MEMORANDUM

Subject: **RZ 15-021:** Pursuant to the City of Dunwoody Zoning Ordinance, §27-330, applicant, Cypress Communities, LLC, on behalf of CQ Dunwoody Village Court, LLC, seeks permission to rezone property currently zoned Office-Institution (O-I) District to Multi-dwelling Residential District (RM-100) to allow for construction of an 81-unit townhome development. The subject property consists of two parcels: tax parcel 18-366-060-61 located at 1530 Dunwoody Village Parkway, Dunwoody, GA 30338, and tax parcel 18-366-060-65 located at 1536 Dunwoody Village Parkway, Dunwoody, GA 30338.

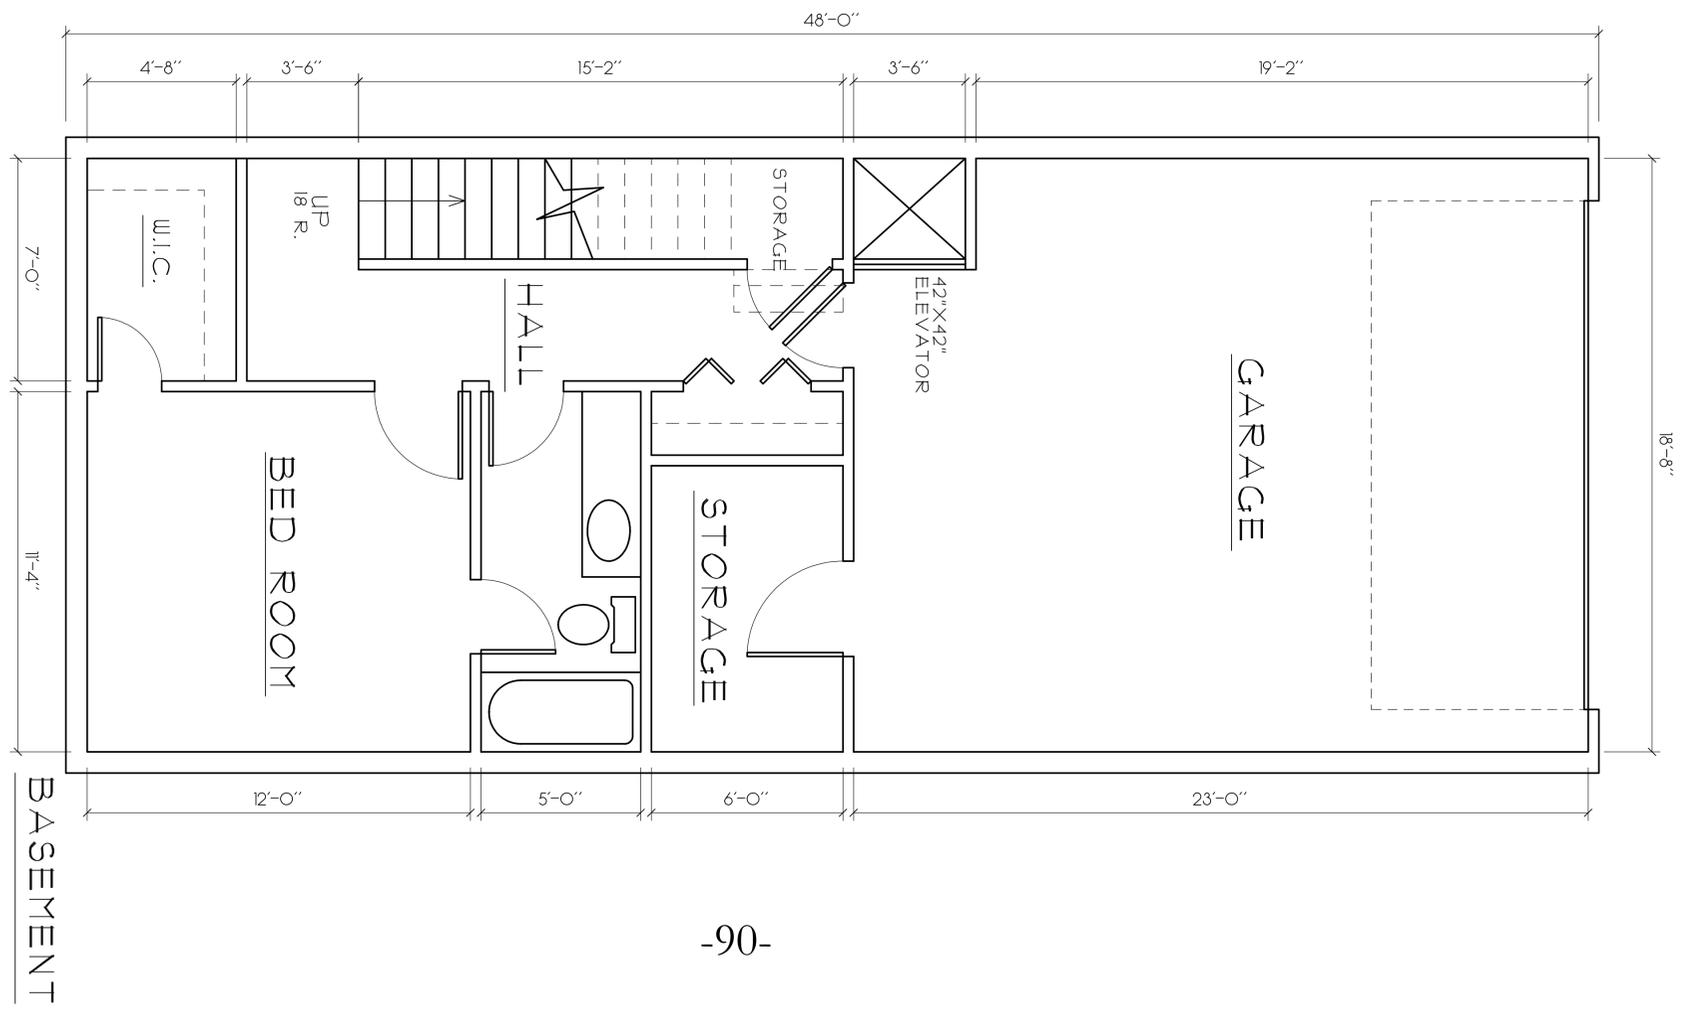
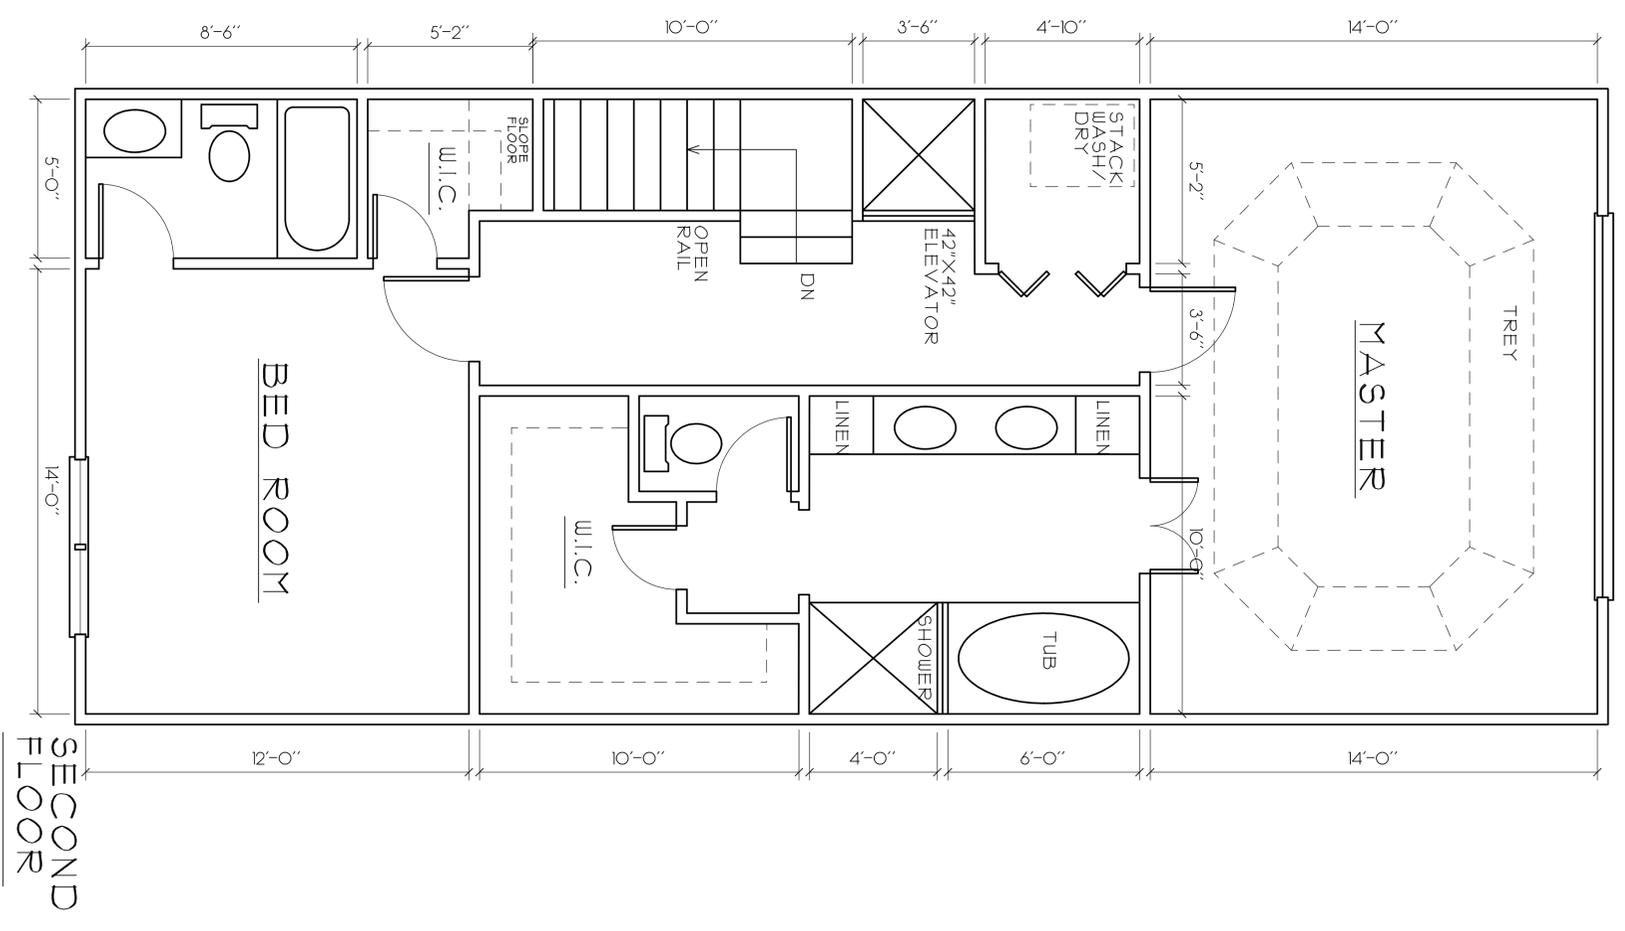
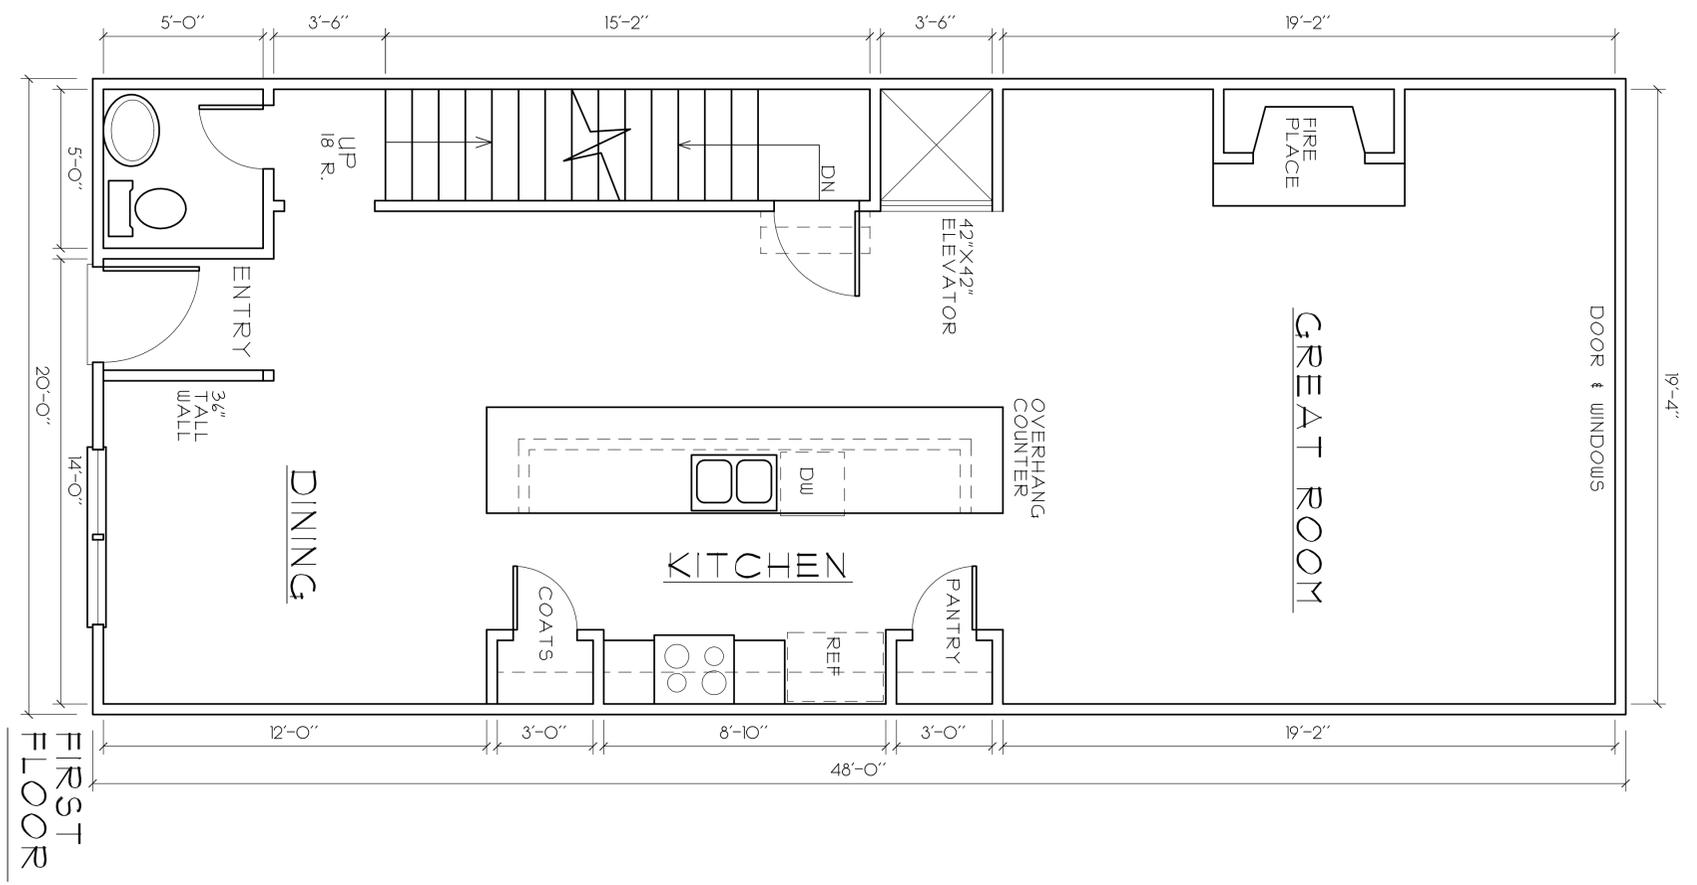
1. New drawing showing five adjacent units has been provided to give a more accurate depiction of the aesthetics of the buildings. These front elevations are representative of all buildings.
2. A wider stoop/porch has been added to several of the units to improve the appearance of the units and interaction with the street/pedestrians.
